GLENORCHY PLANNING AUTHORITY

AGENDA

MONDAY, 16 MAY 2016

5. PROPOSED USE AND DEVELOPMENT - ADDITIONS TO EXISTING DANCE STUDIO (SPORTS AND RECREATION) - 1A BOSCO DRIVE, GLENORCHY

Figure 4. Snapshot from ListMaps showing the site within the electricity transmission corridor of the Electricity Transmission Infrastructure Protection Code. The area shown in orange is the inner protection area of the electricity transmission corridor.

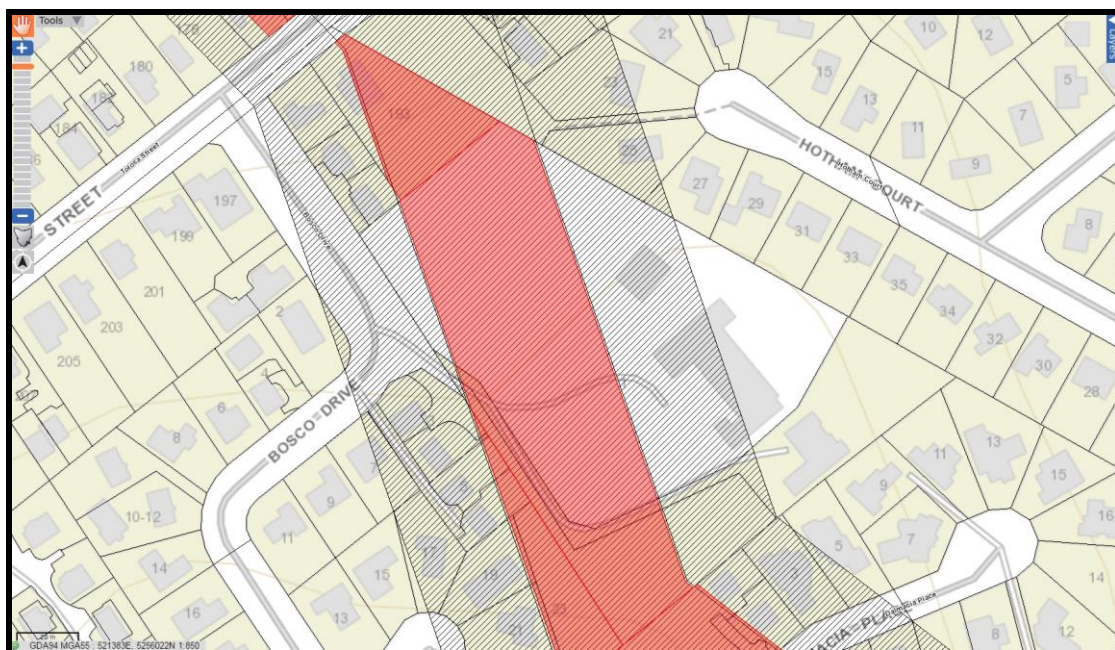
The proposed dance studio is not to be located within the inner protection area of the electricity transmission corridor or within the registered electricity easement. However, the parking spaces are proposed to be within the inner protection area of the electricity transmission corridor and are to be within the registered electricity easement (Fig. 4).

The proposal relies on performance criteria P1 of Clause E8.7.1 Development within the electricity transmission corridor. The performance criteria requires development to be located an appropriate distance from electricity transmission infrastructure, having regard to the need to ensure operational efficiencies of electricity transmission infrastructure; the provision of access and security to existing or future electricity transmission infrastructure; safety hazards associated with proximity to existing or future electricity transmission infrastructure; and the requirements of the electricity transmission entity.

TasNetworks has no objections to the proposal. However, it is requested that construction of the new car parking spaces under the existing transmission line be undertaken in consultation with TasNetworks to ensure appropriate ground clearances are maintained for these assets and the protection of the car park users into the future. TasNetworks can provide the developer with guidelines for working safely near electricity lines to assist in this regard.

FIGURE 3: Excerpt from Exponare of Council's Inundation Overlay.

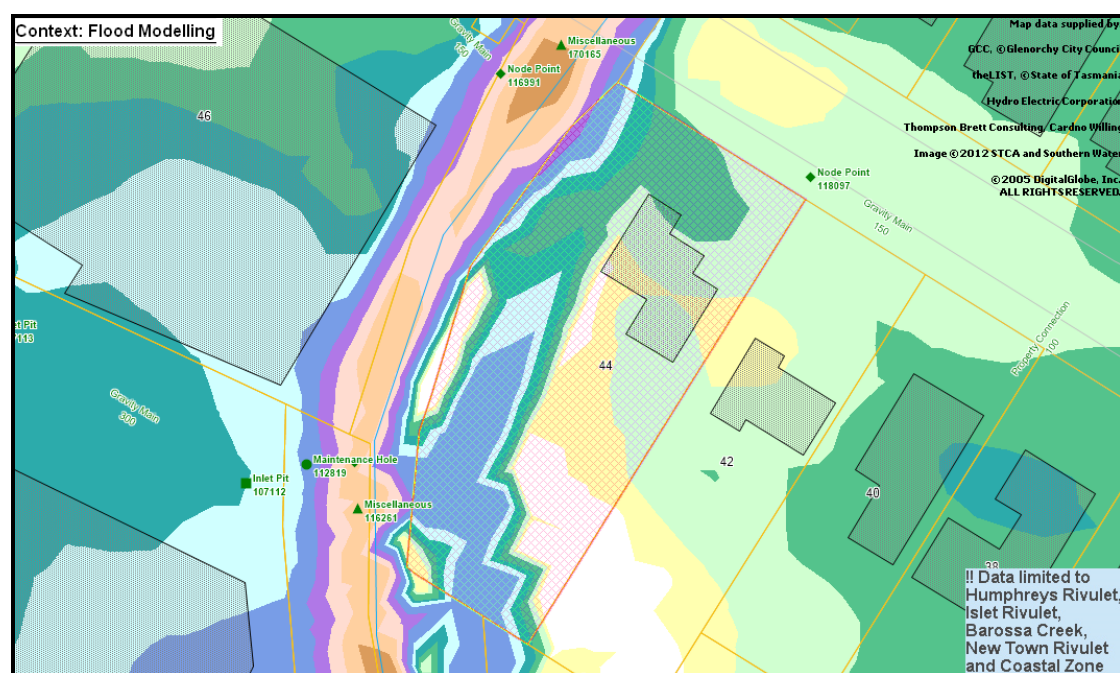
'Given there is considerable flood risk identified in the previous flood studies and known to the Council through historical records, it is envisaged that floods will occur at this location again in the foreseeable future, and it is important that any development at this location addresses the potential inundation and flood risks.'

According to the submitted drawings received on 29th July 2015 and amended plans received on 12th Feb 2016, the proposed development is aiming to add two additional units, within the same lot, at the rear of an existing single dwelling (white building showing in the photos above). The existing single dwelling will be retained in the same location, and these two new units will be elevated by steel posts installed underneath the buildings to provide structural support, and to allow overland flow to pass through the site during major rainfall events.

21. The minimum floor level for all habitable rooms shall be minimum 300 mm above the 1% AEP flood level.
22. Prior to the issuing of the Building Permit the applicant shall enter into a registered agreement pursuant to Part 5 of the Land Use Planning and Approvals Act 1993, for the Area that Unit 2 & 3 occupies, including the building footprint, parking space, driveway and Private Open Space (POS), which is subject to this permit.

Figure 5. An excerpt from the submitted plans showing the extent of the building protruding outside the building envelope.

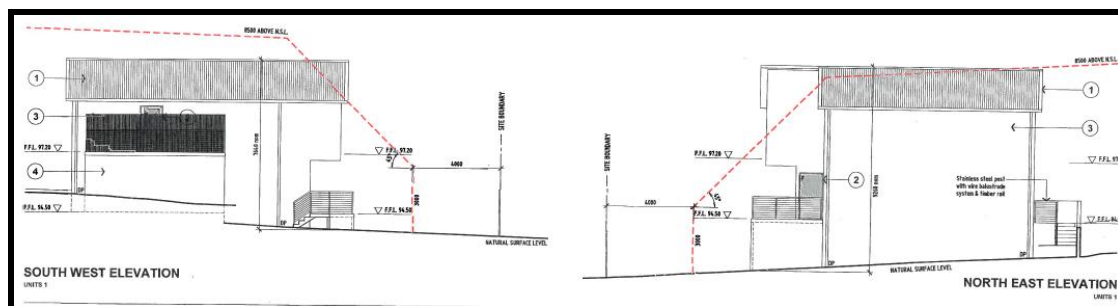
The south-eastern elevation of proposed dwelling unit 1 extends outside the vertical building envelope (Fig. 5).

Shadow diagrams demonstrate that the adjoining property would not be unreasonably overshadowed. Proposed dwelling 1 is to be setback more than 4 metres from the rear boundary and is considered to be adequately separated from the adjoining vacant lot. Proposed dwelling 1 is assessed as satisfying the performance criteria.

Figure 6. An excerpt from the submitted plans showing the extent of proposed dwelling units 2 and 3 protruding outside the building envelope.

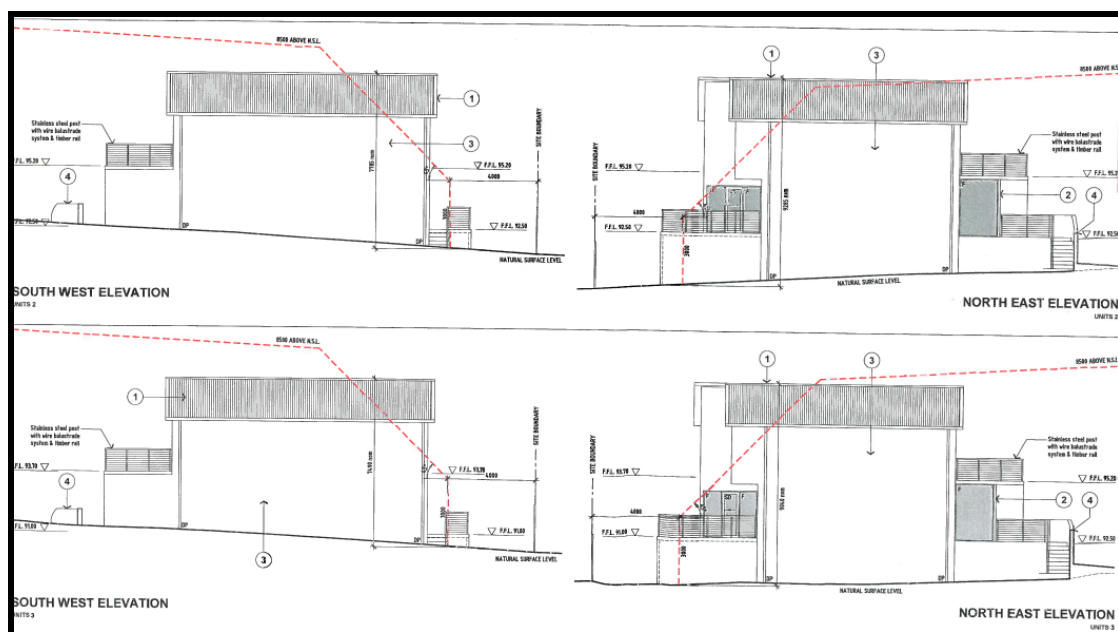
Proposed dwellings 2 and 3 extend outside vertical building envelope and are setback less than 4 metres from the south-eastern rear boundary. The north-western elevation of proposed dwellings 2 and 3 are to sit within the vertical building envelope. However, as the site slopes away, the south-eastern elevations of these dwellings, adjacent to the rear boundary, extend outside of the building envelope. It is noted that the elevated ground-floor courtyards are to be setback 3 metres from the rear boundary setback (Fig. 6).

Landscaping in the form of trees and shrubs is proposed along the rear boundary adjacent to dwellings 1, 2 and 3. The submitted shadow diagrams demonstrate that the proposed dwellings would not unreasonably overshadow the neighbouring properties. Given the vegetative screening and the lack of overshadowing of the neighbouring properties, the proposal is assessed as not causing an unreasonable loss of amenity through siting or scale.

Figure 3. Excerpt of the site plan depicting the location of the rear boundary setbacks for proposed dwelling units 2, 3 and 4, circled in blue.

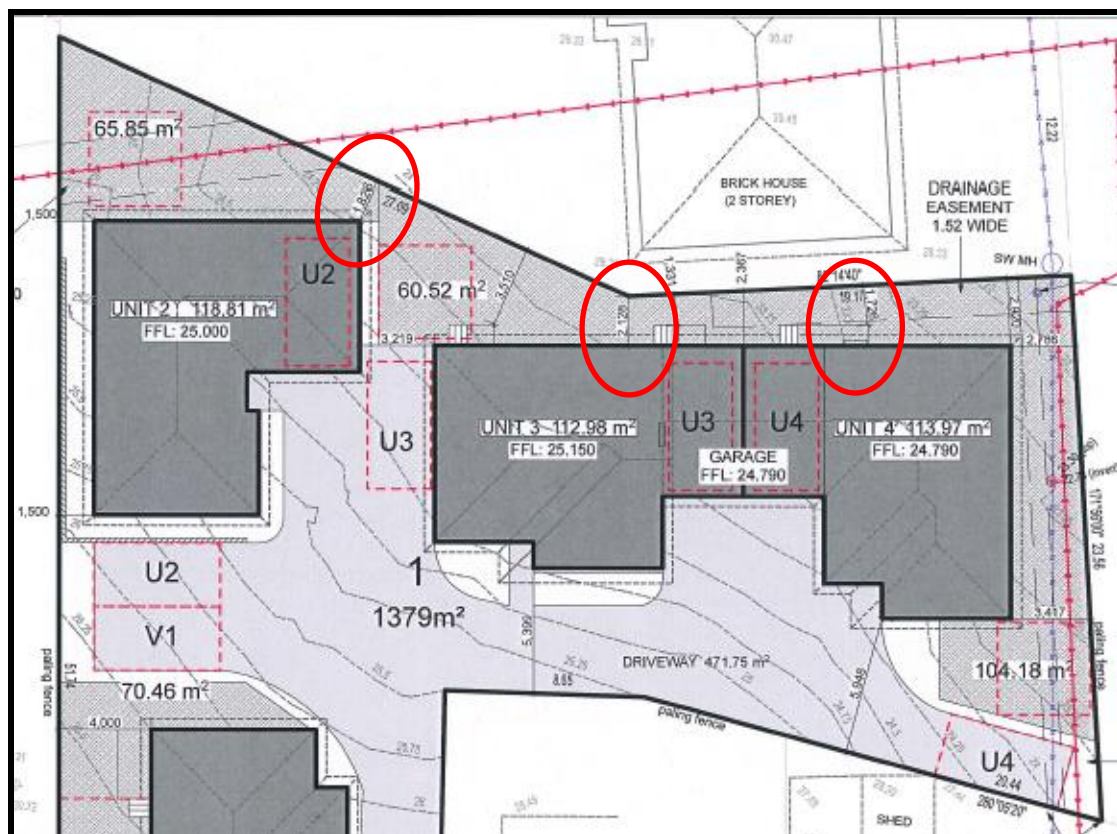
Proposed dwelling 2, 3 and 4 are to have a rear boundary setback less than the required 4m. The proposal relies on performance criteria P3. (Fig. 3).

Figure 4. An excerpt of the site plan showing the location of the private outdoor space of dwelling 4

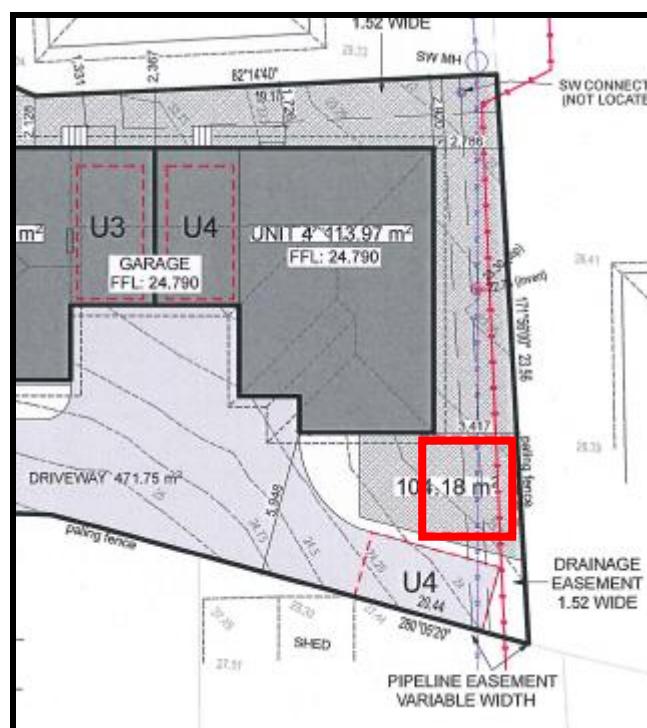
The siting of the private outdoor space dedicated to proposed dwelling 4 is not directly accessible from or adjacent to a habitable room other than a bedroom and relies on the performance criteria (Fig. 4).

The performance criteria requires a dwelling to have private open space that includes an area that is capable of serving as an extension of the dwelling for outdoor relaxation, dining, entertaining and children's play and that is conveniently located in relation to a living area of the dwelling; and orientated to take advantage of sunlight.
